Project Name		CASp Survey #	Date
Heller Park		532004	5/12/2014 5/14/2014
Address		Weather	Temperature
257 16 th Street Costa Mesa, CA		Sunny	79° F 95° F
CASp Inspector	Owner	Start Time	Finish Time
Steve Miller #532	City of Costa Mesa	9:00 am 8:00 am	11:30 am 1:30 pm

Introduction

Findings

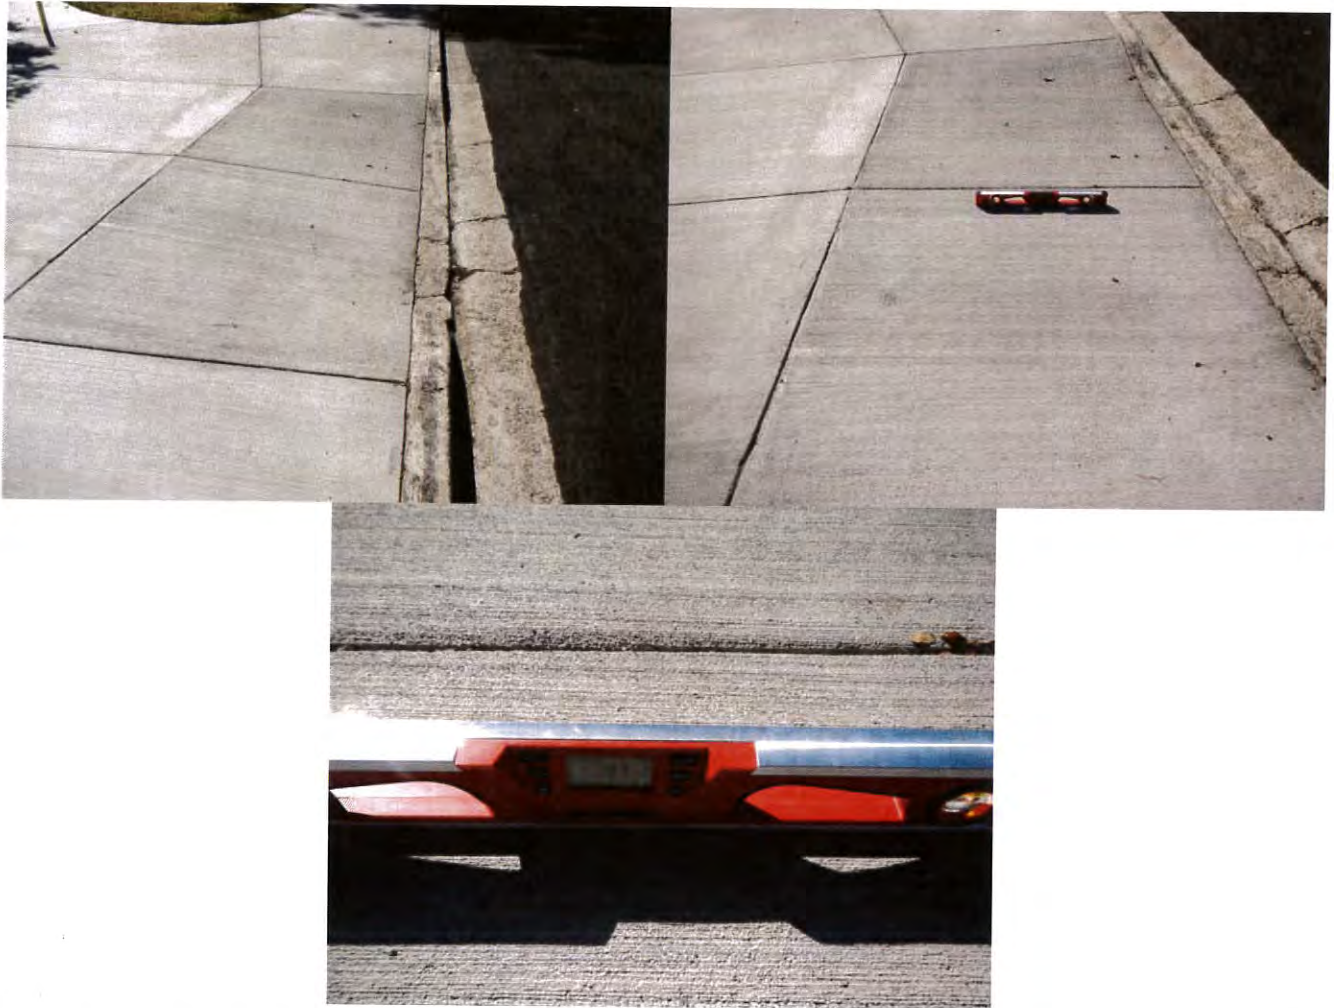
- 2) 3.0% cross slope in excess of 1:48 at west end of sidewalk on 16th Street. (2013 CBC 11B403.3)

Provide walkways with 1:20 maximum slope in the direction of travel and 1:48 cross slope.

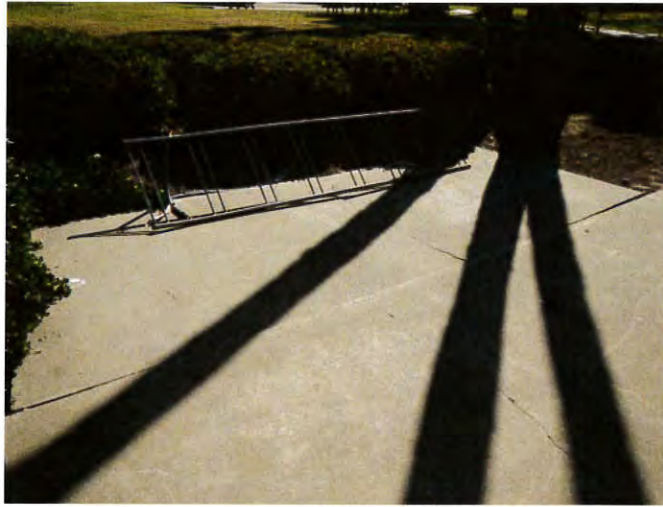
- 6) There are no detectable warnings for the curb ramp at east end of sidewalk on 16th Street. (2013 CBC 11B705.1)

Provide 36" deep detectable warnings (truncated domes per 2013 CBC 11B705.1) the entire width of the curb ramp excluding the flared sides and the curb depth.

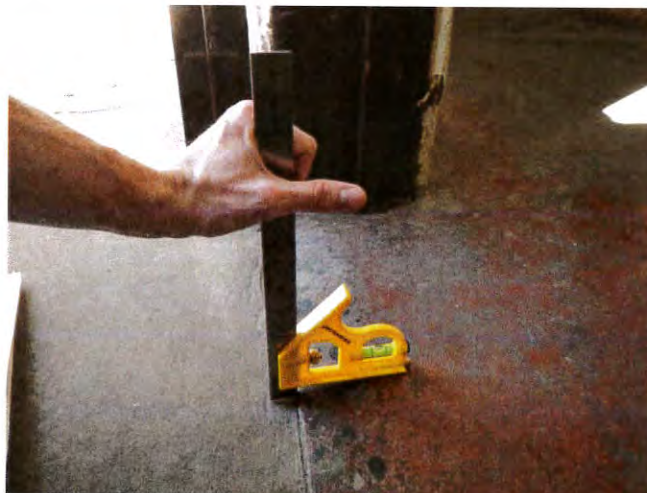
- 1) Drinking fountain protruding into path of travel. (2013 CBC 11B-307.2 and 11B-602.9) 2" high water flow from low drinking fountain is not 4". (2013 CBC 11B-602.6) No drinking fountain for standing persons. (2013 CBC 11B-602.7)

Provide pedestrian protection for drinking fountain per 11B-602.9. Provide water flow 4" high minimum. Provide additional drinking fountain with spout located 38"-43" above finish floor.
